SECTION 96 SUBMISSION

DEE WHY RSL CLUB - 932 PITTWATER ROAD
STAGE 5 CLUB EXTENSION

THIS PLAN TO BE READ IN CONJUNCTION WITH
MOD2018/0119
NORTHERN BEACHES COUNCIL

PROJECT:
STAGE 5 - CLUB EXTENSION
PHASE 2 WORKS - SOUTHERN
CARPARK & ENCLOSURE

DRAWING TITLE:
CLUB LEVEL 3 AND LEVEL 4 -
EXISTING AND DEMOLITION PLAN

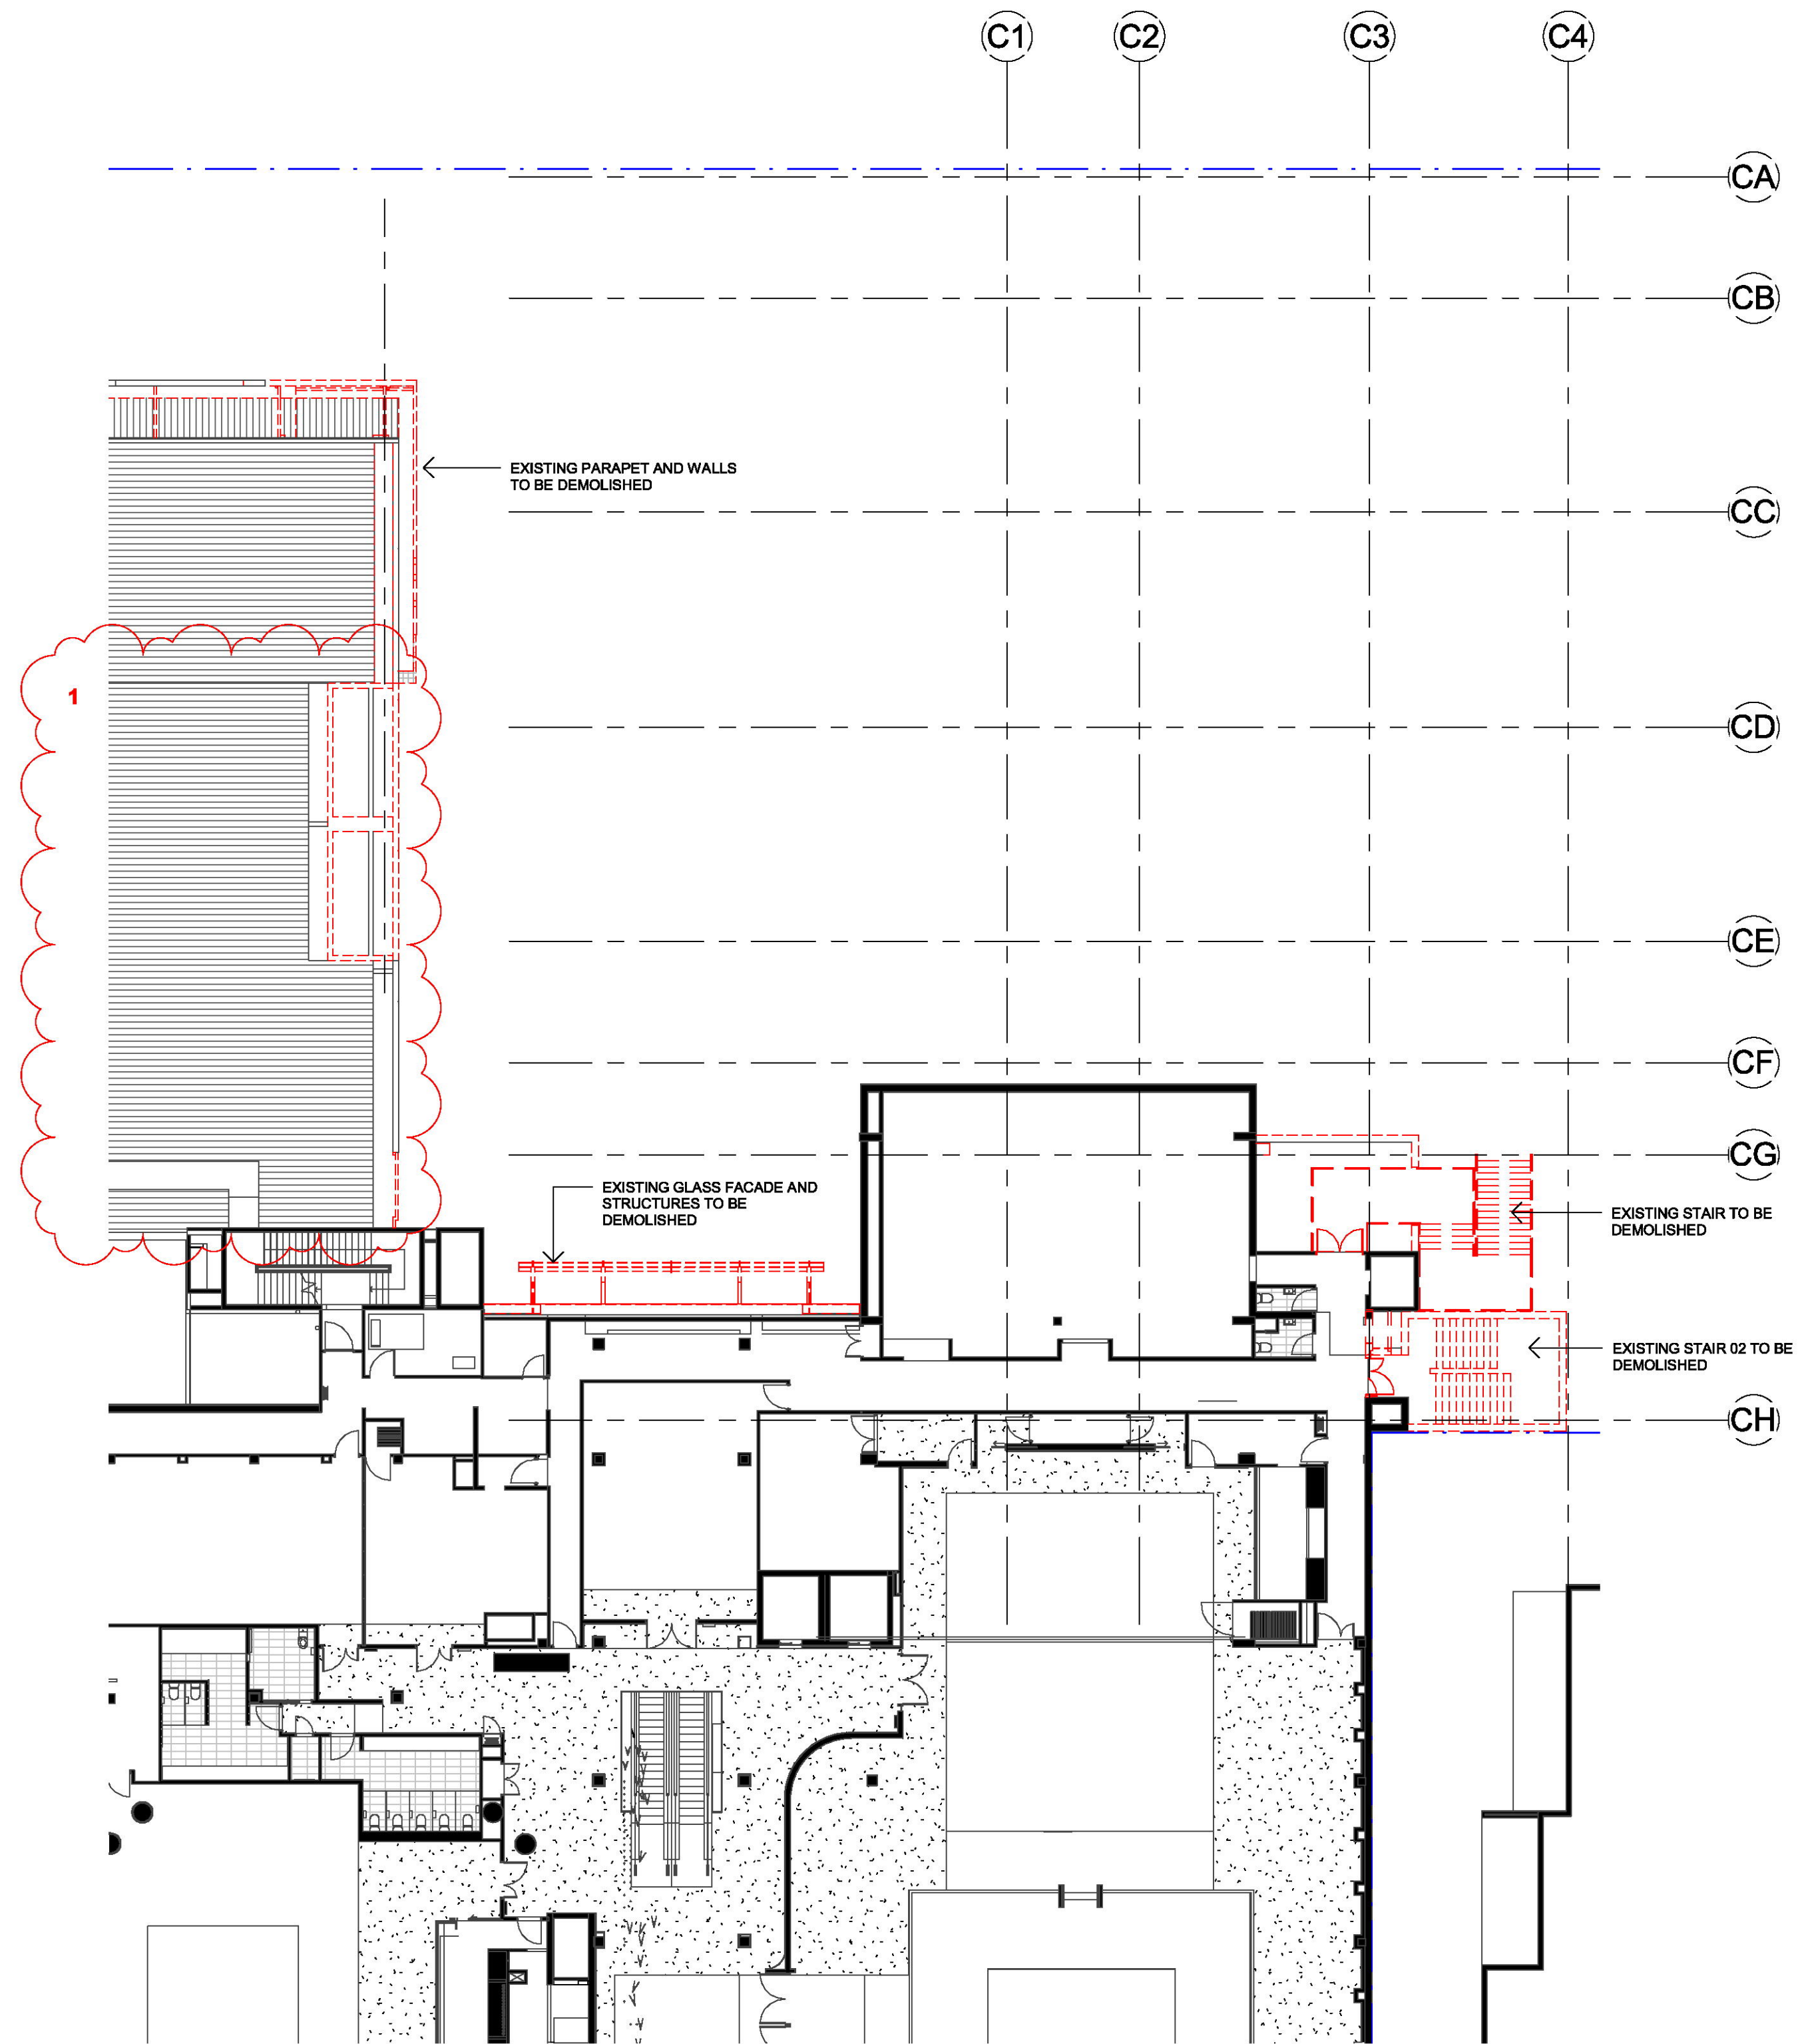
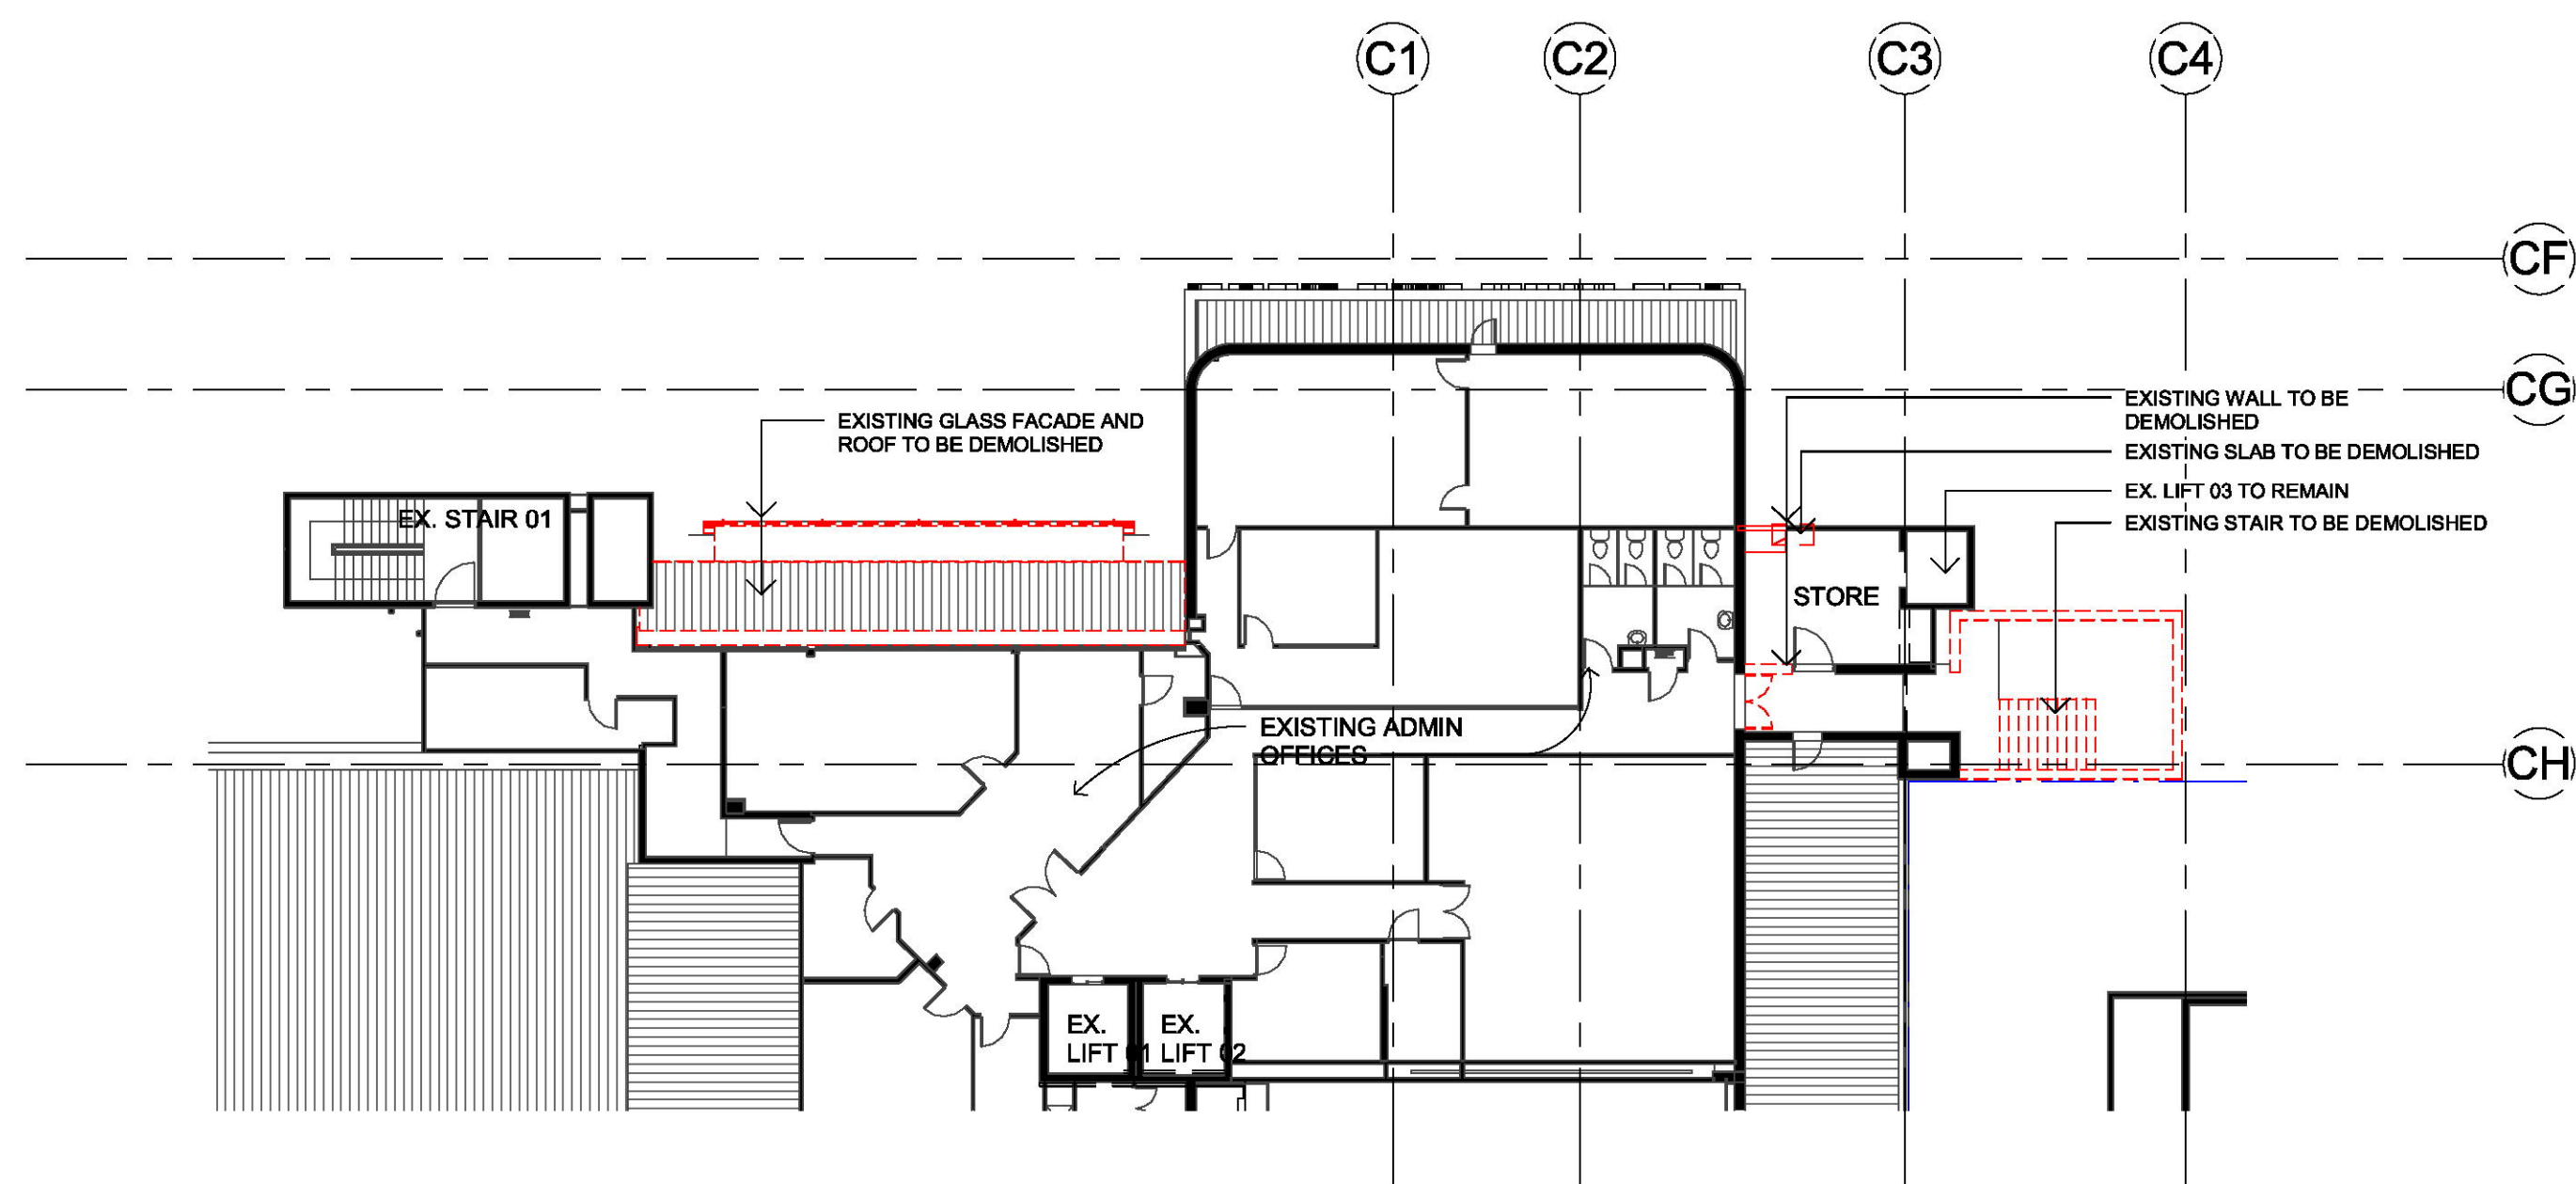
1. RELOCATED OPEN PLANTROOM AT THE ROOF LEVEL
2. MODIFIED ROOF OPENING ABOVE MAIN ENTRANCE
3. MODIFIED CENTRAL SKYLIGHT (REDUCED HEIGHT, MODIFIED PITCH)
4. MODIFIED COURTYARD: TWO OPEN COURTYARDS AND ONE SKYLIGHT COVERED AREA INSTEAD OF ONE LARGE GLASS ROOF, REDUCED HEIGHT AND PITCH
5. MODIFIED SMOKING TERRACE: ROOF OPENING, SIZE AND PLANTED AREA, AREA REDUCED BY 21m²
6. REDUCED NUMBER OF ROOF SKYLIGHTS ABOVE ASIAN RESTAURANT: 2 INSTEAD OF 6 TO SUIT THE NEW INTERNAL LAYOUT
7. MODIFIED EXIT STAIR: POSITION, CONFIGURATION, METAL ROOF NO LONGER REQUIRED
8. CONCRETE ROOF INSTEAD OF METAL DECK ROOF FOR THE MAJORITY OF THE BUILDING EXTENSION
9. NO SLAB ABOVE THE EXPOSED CAR PARK LEVEL 2 IN THE SOUTH AREA
10. NEW ACOUSTIC METAL ROOF ABOVE REVISED LOADING DOCK

- facade
11. MODIFIED FACADE APPEARANCE DUE TO CHANGES IN THE CAR PARK LEVELS, LOADING DOCK AND EGRESS STAIRS
 12. REMOVED LOUVRES ON THE BACK FACADE (WESTERN FACADE) DUE TO MECHANICAL RISER NO LONGER REQUIRED / REVISED LOCATION FOR EGRESS DOORS
 13. 2m WIDE INTERNAL EGRESS STAIR MODIFIED INTO TWO 1m WIDE EXTERNAL STAIRS WITH DECORATIVE BALUSTRADES
 14. EXTENT OF LEVEL 2 (MAIN TRADING LEVEL) REDUCED BY 6328mm FROM THE SOUTHERN BOUNDARY AND INCREASED BY 1100mm TO THE EASTERN BOUNDARY
 15. MODIFIED FACADE CURTAIN WALL MULLION BLADES
 16. CONCRETE BLADE WALL REDUCED BY 1.47m IN HEIGHT AND 6.2m IN LENGTH
 17. VERTICAL FINS REMOVED FROM BACK WALL (WESTERN FACADE)

- ground/landscape/floor plate
18. REVISED LOADING DOCK ENTRANCE AND LOCATION/ ENLARGED DEMOLISHED AREA IN THE EXISTING RETAINED SOUTHERN CAR PARK
 19. NEW / MODIFIED EGRESS PATHS FROM EXISTING CARPARK LEVEL -1, NEW CARPARK LEVEL 1.

20. RELOCATED ELECTRICAL SUBSTATION / LANDSCAPED AREA MOVED TO SUIT
 21. MEDIAN STRIP ADDED AT ENTRY TO PROVIDE PLACE OF REFUGE AND ENSURE WIDTH OF ENTRY/ EXIT IS LESS THAN 8M AS PER DA CONDITION 23

24. BASEMENT CAR PARK LEVEL -5 ADDED.
 25. CAR PARK ENTRY / EXIT MOVED TOWARD NORTH BY 3044mm
 26. PLANTER MODIFIED ON THE BACK (WESTERN) FACADE DUE TO REDUCTION OF THE MAIN TRADING FLOOR SLAB

27. LOCATION OF AIR INTAKE MODIFIED
 28. EXTENT OF RESTAURANT REDUCED BY 136m²
 29. CLUB ENTRANCE ACCESSIBLE RAMPS MODIFIED
 30. ONE ADDITIONAL EXISTING CAR PARK SPACE TO BE REMOVED FROM EXISTING NORTHERN CAR PARK

31. SOLID MASONRY WALL ADDED BETWEEN EXISTING ZONE D CAR PARK AND LOADING DOCK ACCESS.

DRAWING TITLE:
KEY PLAN - CARPARK LEVEL 1

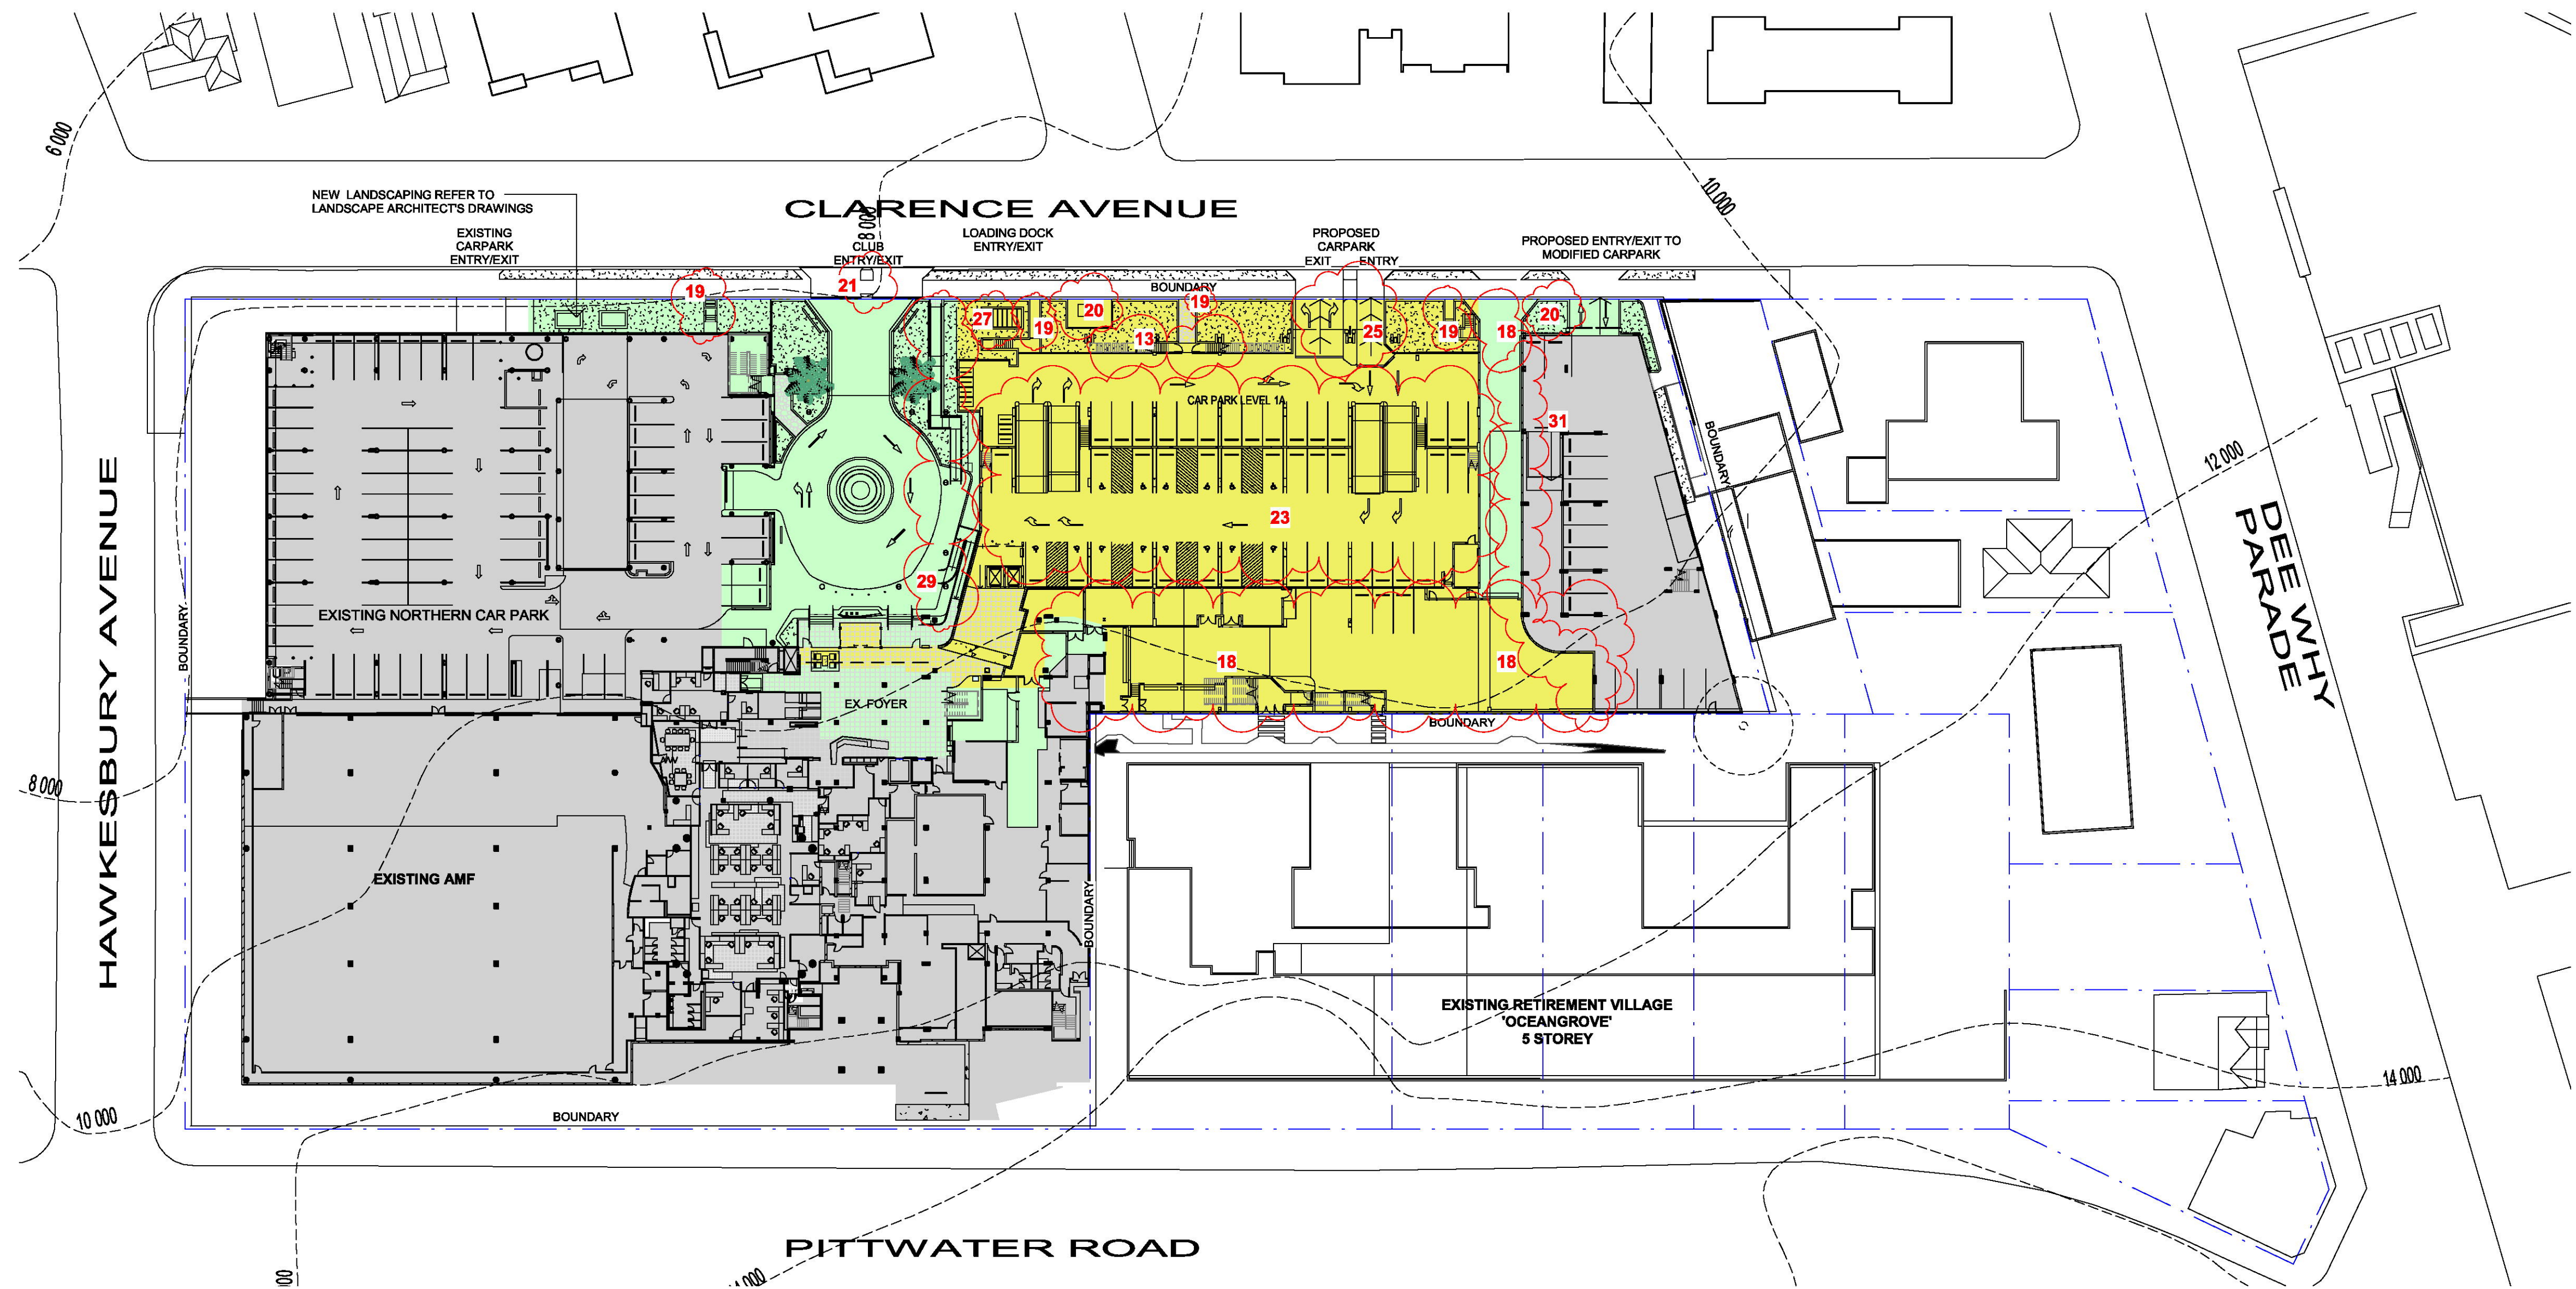
- roof
1. RELOCATED OPEN PLANTROOM AT THE ROOF LEVEL
 2. MODIFIED ROOF OPENING ABOVE MAIN ENTRANCE
 3. MODIFIED CENTRAL SKYLIGHT (REDUCED HEIGHT, MODIFIED PITCH)
 4. MODIFIED COURTYARD: TWO OPEN COURTYARDS AND ONE SKYLIGHT COVERED AREA INSTEAD OF ONE LARGE GLASS ROOF. REDUCED HEIGHT AND PITCH
 5. MODIFIED SMOKING TERRACE: ROOF OPENING, SIZE AND PLANTED AREA, AREA REDUCED BY 21m²
 6. REDUCED NUMBER OF ROOF SKYLIGHTS ABOVE ASIAN RESTAURANT. 2 INSTEAD OF 8 TO SUIT THE NEW INTERNAL LAYOUT
 7. MODIFIED EXIT STAIR: POSITION, CONFIGURATION, METAL ROOF NO LONGER REQUIRED
 8. CONCRETE ROOF INSTEAD OF METAL DECK ROOF FOR THE MAJORITY OF THE BUILDING EXTENSION
 9. NO SLAB ABOVE THE EXPOSED CAR PARK LEVEL 2 IN THE SOUTH AREA
 10. NEW ACOUSTIC METAL ROOF ABOVE REVISED LOADING DOCK

- facade
11. MODIFIED FACADE APPEARANCE DUE TO CHANGES IN THE CAR PARK LEVELS, LOADING DOCK AND EGRESS STAIRS
 12. REMOVED LOUVRES ON THE BACK FACADE (WESTERN FACADE) DUE TO MECHANICAL RISER NO LONGER REQUIRED / REVISED LOCATION FOR EGRESS DOORS
 13. 2m WIDE INTERNAL EGRESS STAIR MODIFIED INTO TWO 1m WIDE EXTERNAL STAIRS WITH DECORATIVE BALUSTRADES
 14. EXTENT OF LEVEL 2 (MAIN TRADING LEVEL) REDUCED BY 8328mm FROM THE SOUTHERN BOUNDARY AND INCREASED BY 1100mm TO THE EASTERN BOUNDARY
 15. MODIFIED FACADE CURTAIN WALL MULLION BLADES
 16. CONCRETE BLADE WALL REDUCED BY 1.47m IN HEIGHT AND 6.2m IN LENGTH
 17. VERTICAL FINS REMOVED FROM BACK WALL (WESTERN FACADE)

- ground/landscape/floor plate
18. REVISED LOADING DOCK ENTRANCE AND LOCATION/ ENLARGED DEMOLISHED AREA IN THE EXISTING RETAINED SOUTHERN CAR PARK
 19. NEW / MODIFIED EGRESS PATHS FROM EXISTING CARPARK LEVEL -1. NEW CARPARK LEVEL 1.

20. RELOCATED ELECTRICAL SUBSTATION / LANDSCAPED AREA MOVED TO SUIT
 21. MEDIAN STRIP ADDED AT ENTRY TO PROVIDE PLACE OF REFUGE AND ENSURE WIDTH OF ENTRY/ EXIT IS LESS THAN 8M AS PER DA CONDITION 23

24. BASEMENT CAR PARK LEVEL -5 ADDED.
 25. CAR PARK ENTRY / EXIT MOVED TOWARD NORTH BY 3044mm
 26. PLANTER MODIFIED ON THE BACK (WESTERN) FACADE DUE TO REDUCTION OF THE MAIN TRADING FLOOR SLAB

27. LOCATION OF AIR INTAKE MODIFIED
 28. EXTENT OF RESTAURANT REDUCED BY 136m²
 29. CLUB ENTRANCE ACCESSIBLE RAMPS MODIFIED
 30. ONE ADDITIONAL EXISTING CAR PARK SPACE TO BE REMOVED FROM EXISTING NORTHERN CAR PARK

31. SOLID MASONRY WALL ADDED BETWEEN EXISTING ZONE D CAR PARK AND LOADING DOCK ACCESS.
